COMMISSION OF ARCHITECTURAL REVIEW

APPLICATION FOR CERTIFICATE OF APPROPRIATENESS

Address 524-526 N. 1st Street
Historic district Jackson Ward

Re: 524-526 North 1st Street – Richmond
Part 2 Response
DHR # 2017-252

ELEVATIONS
A.301

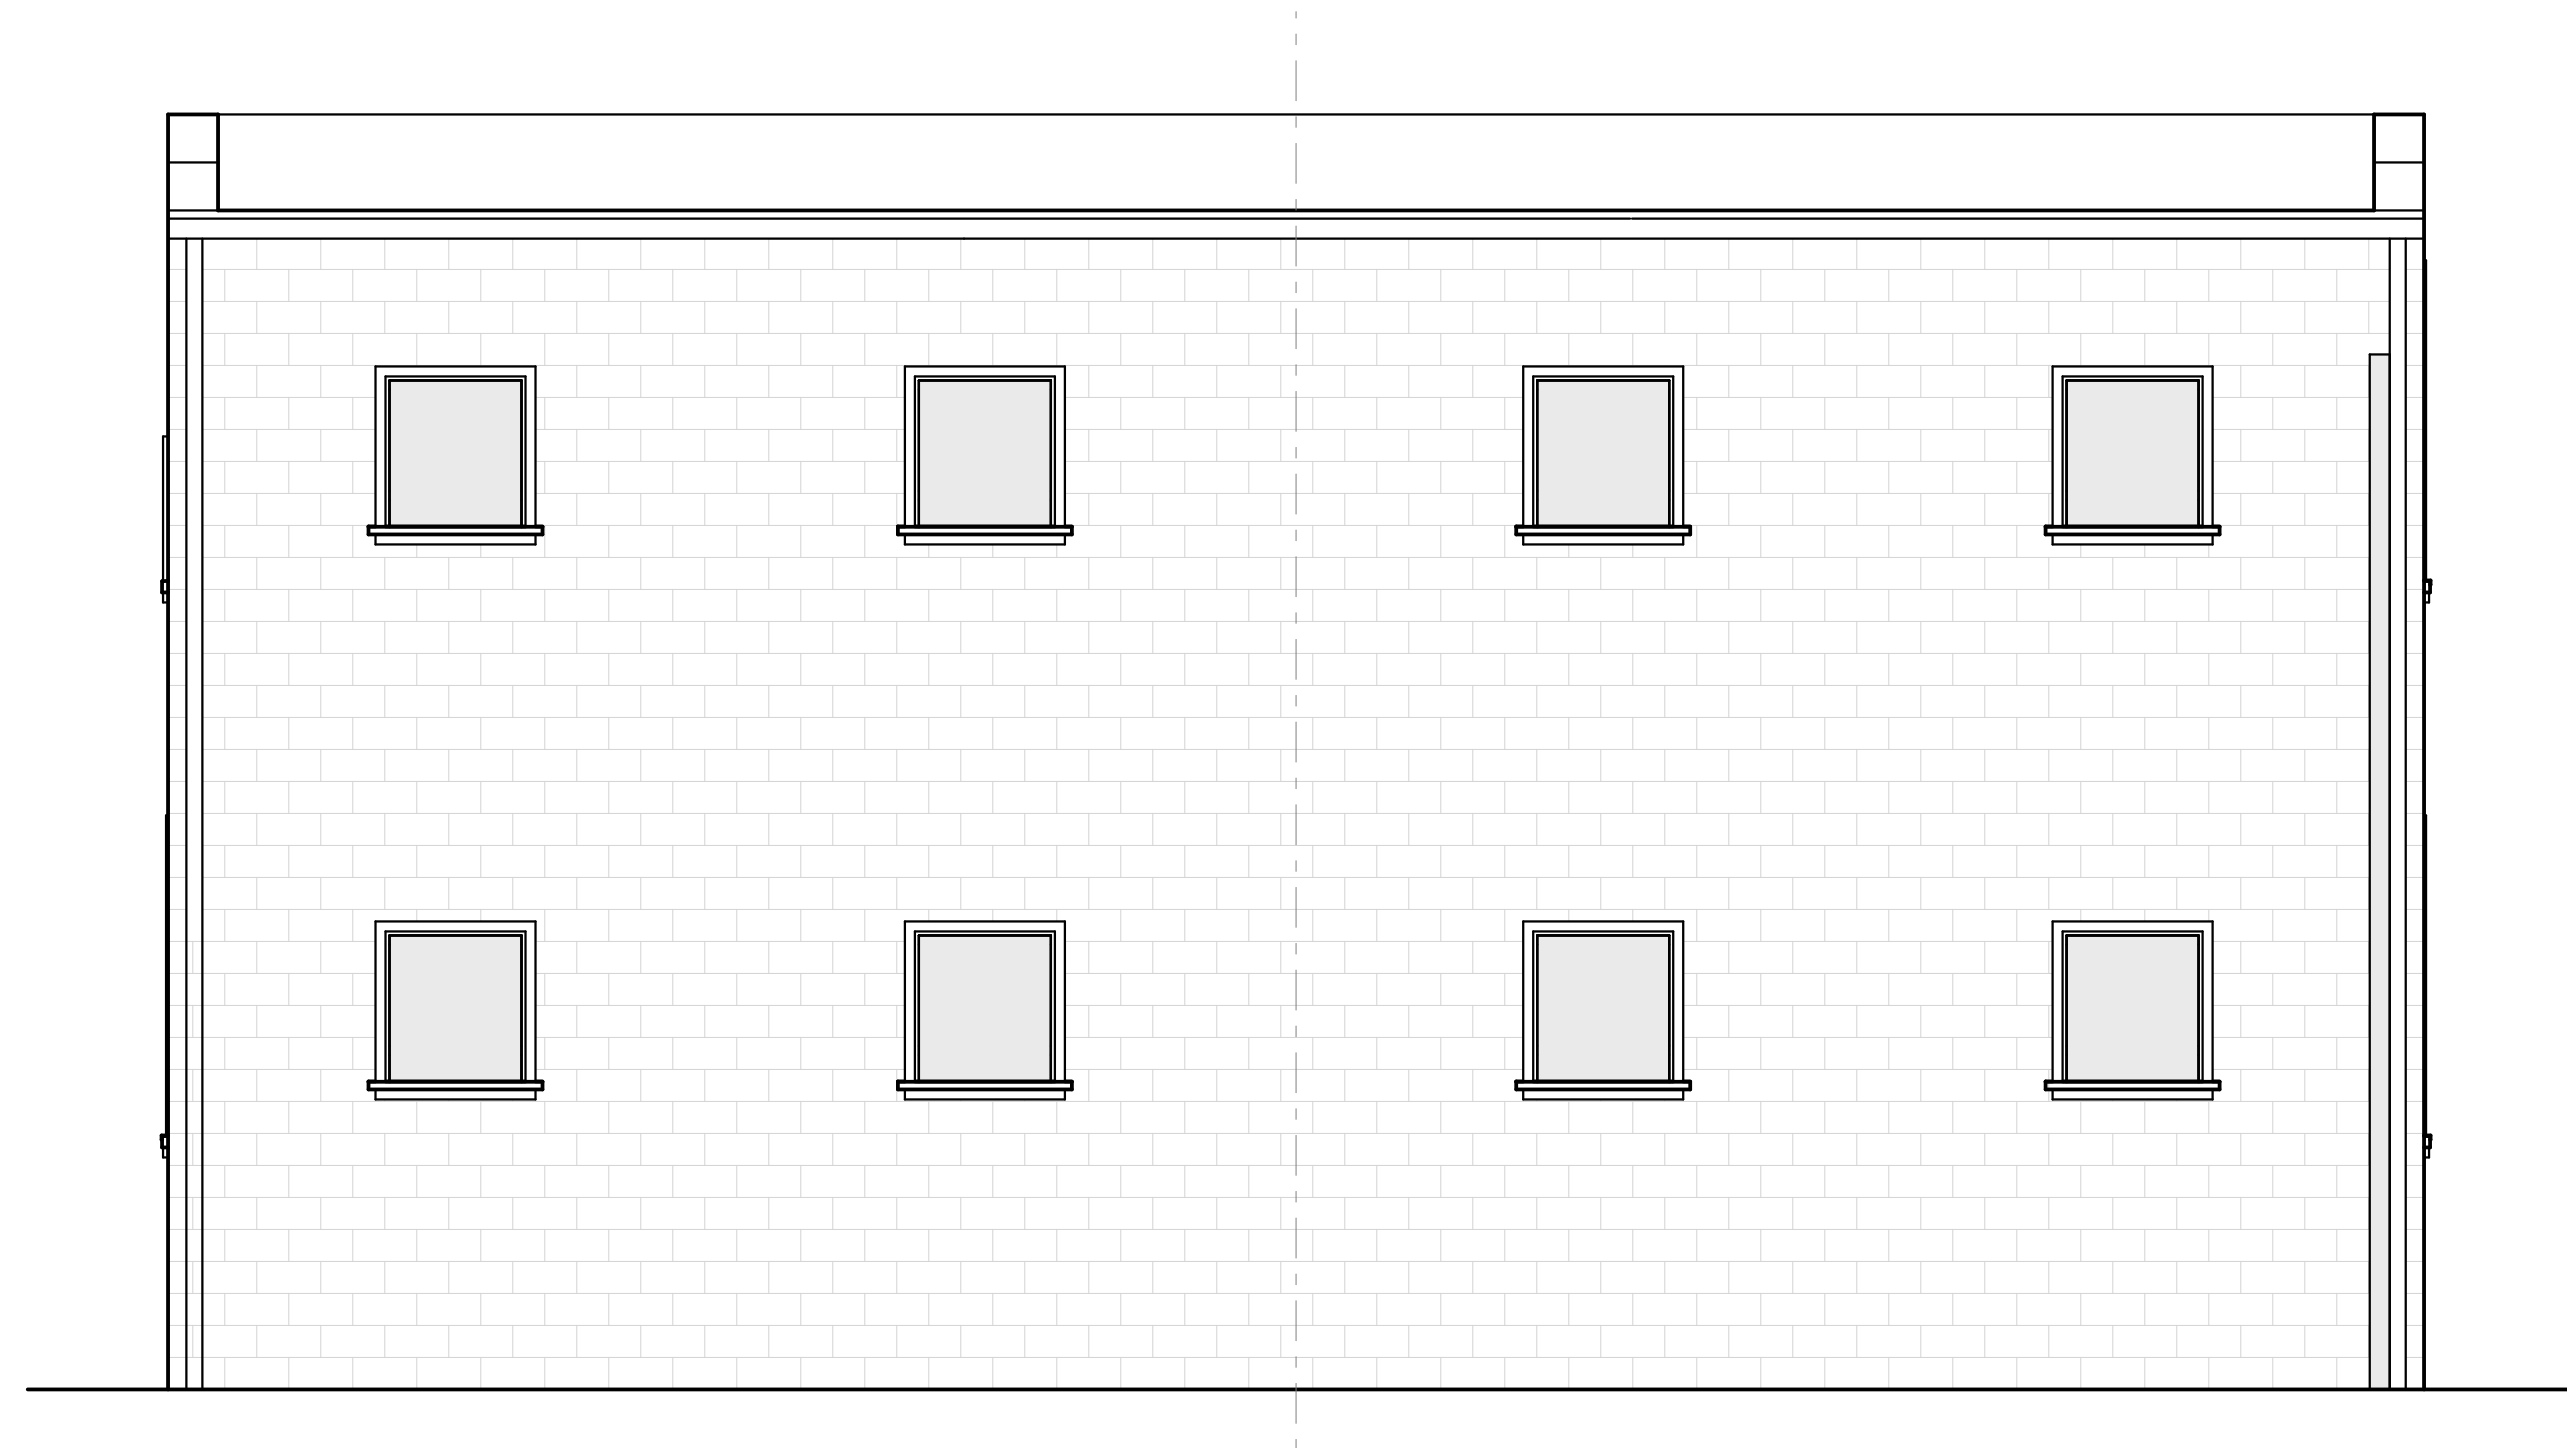
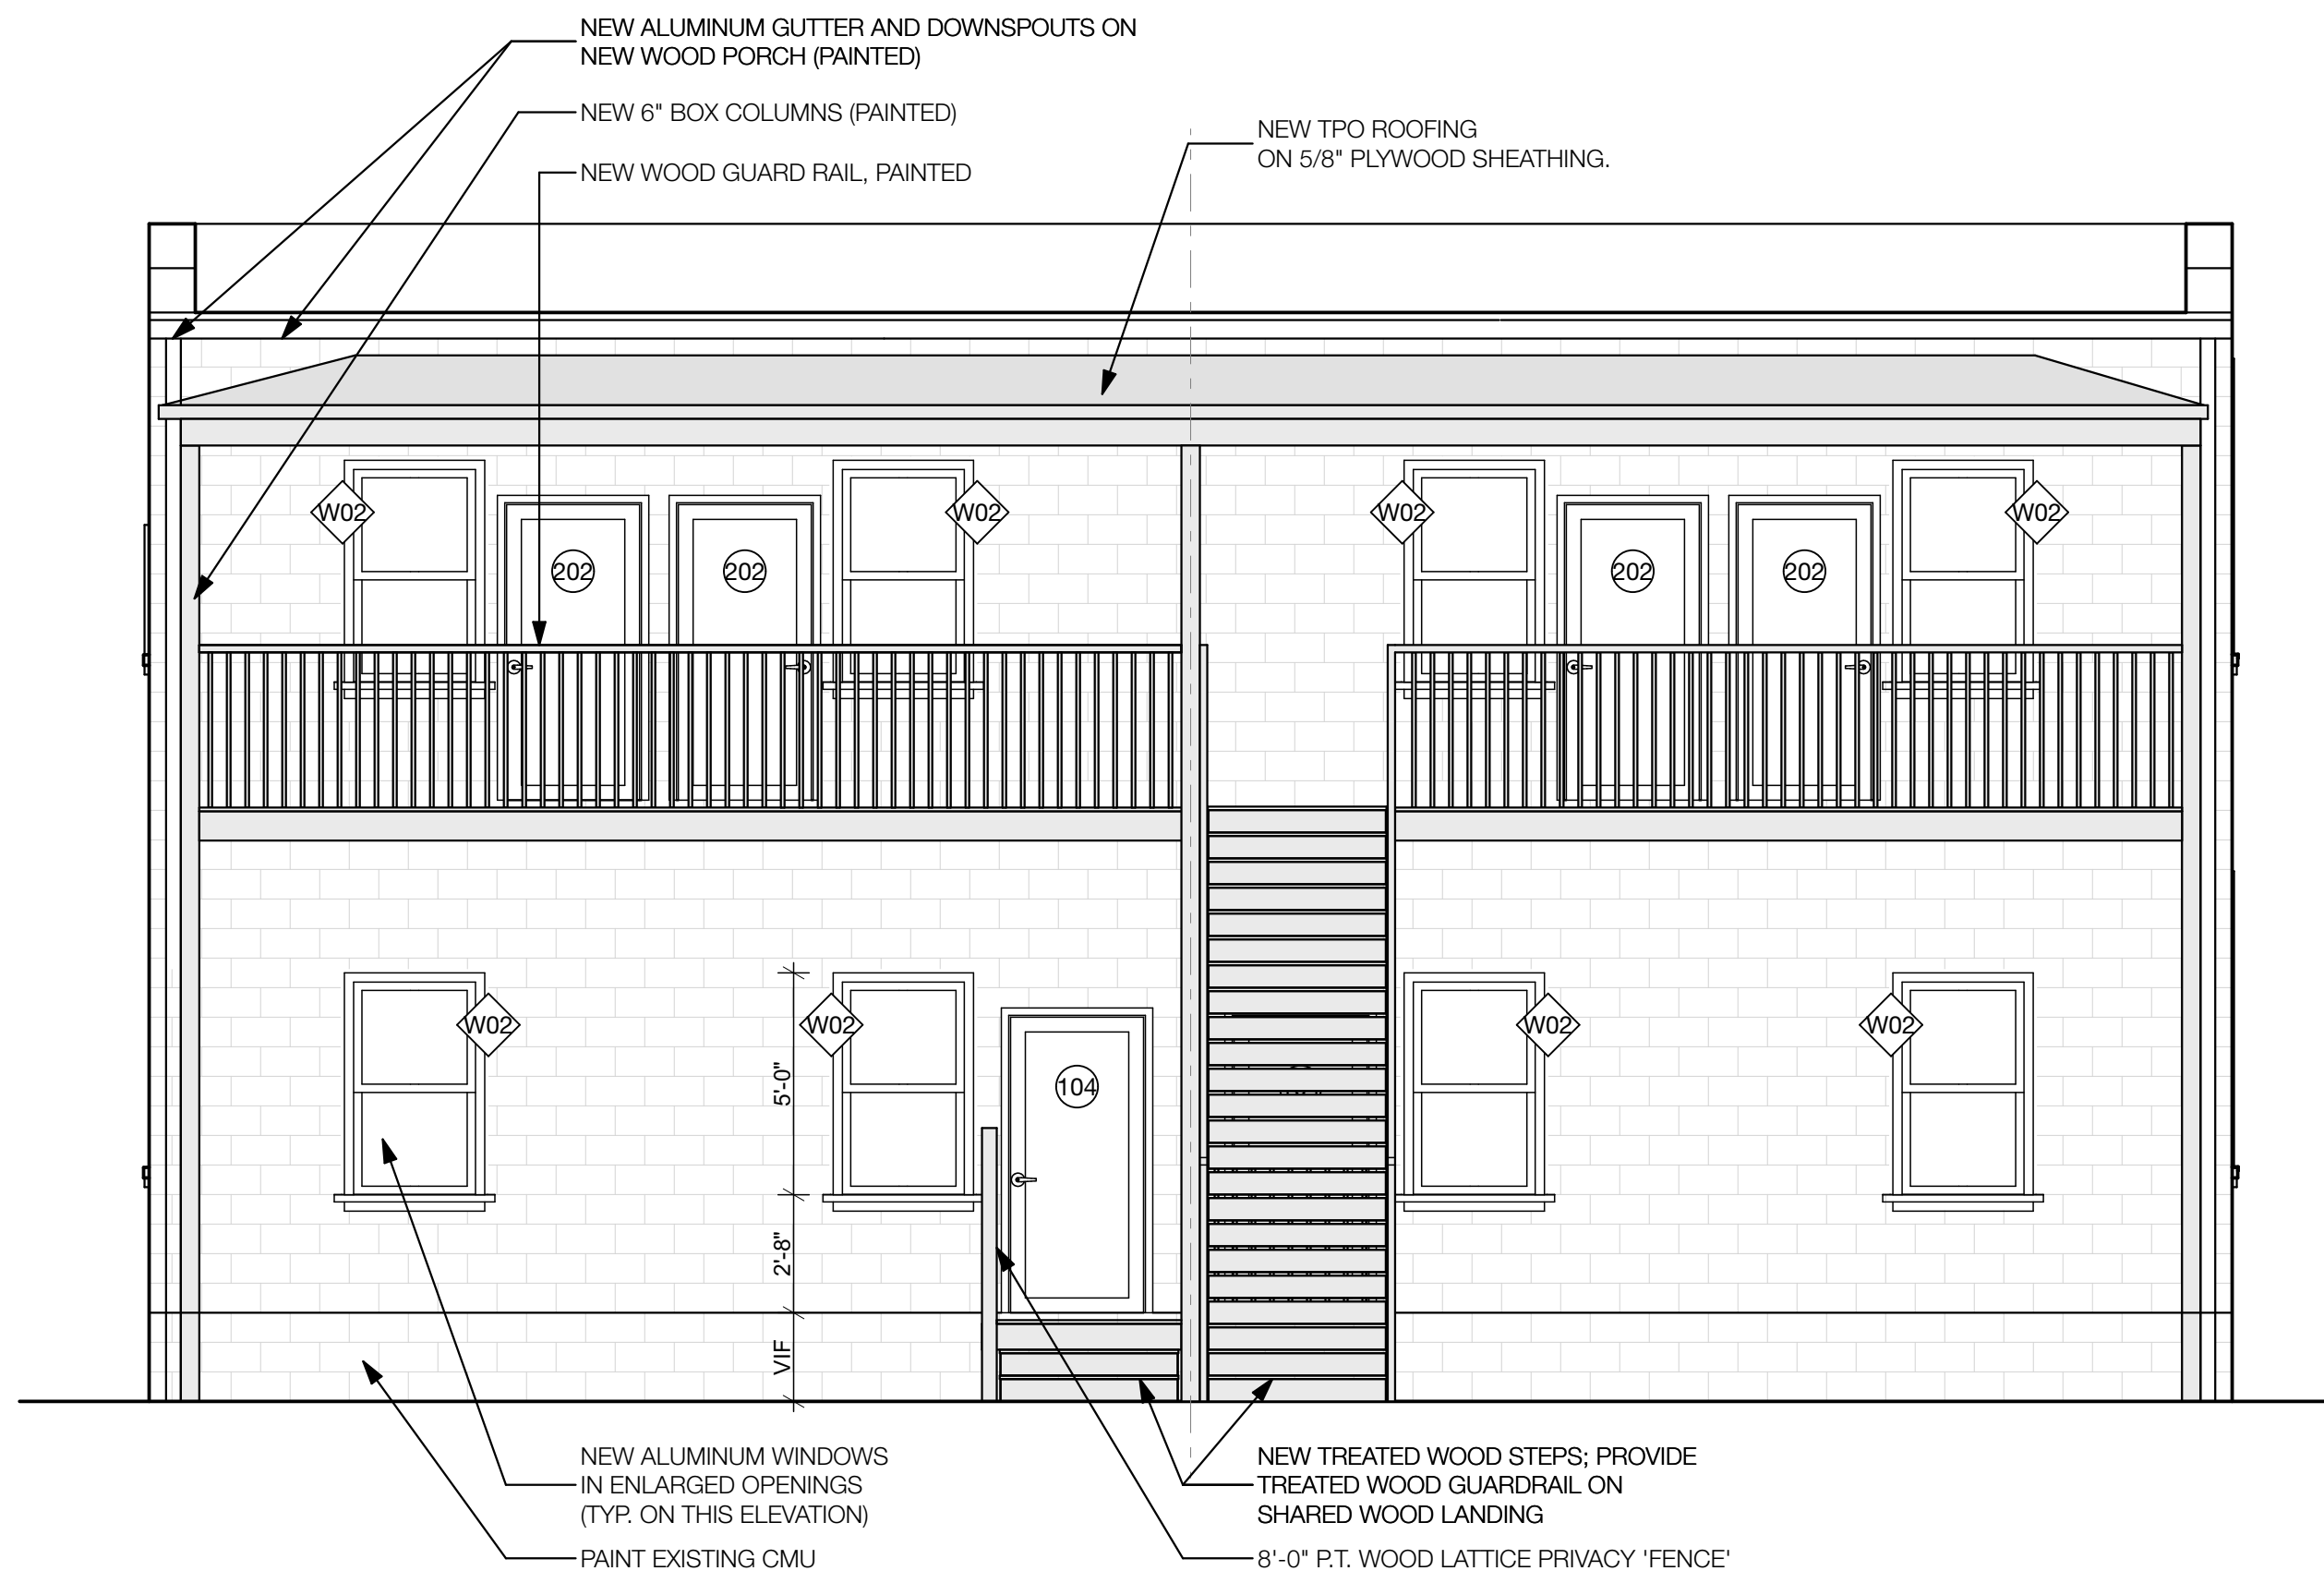
Rear Porch – As this new porch is to be installed off of a non-historic CMU addition, the porch should be contemporary and compatible in design, and should not seek to replicate historic features found elsewhere on the structure. If the historic appropriateness of the new hipped-roof front porch is based on the National Register nomination and Sanborn maps, then the new rear porch should not seek to match the front porch in details. Therefore, please differentiate the rear porch roof so as to provide the necessary differentiation required by *Standard #9*:

First Floor Front Elevation Windows – Please provide additional information on why 2-over-4 light windows are appropriate for this historic structure. This is not a light configuration typically found on historic structures of this style and period, and so it is unclear how the decision was made to use this distinctive type of window. If historic evidence does not substantiate the use of 2-over-4 light windows on the first floor the front elevation, the new windows should be either 2-over-2 light – as was previously found on the second floor of this structure based on 2007 Google street view images, or simple 1-over-1 light windows.
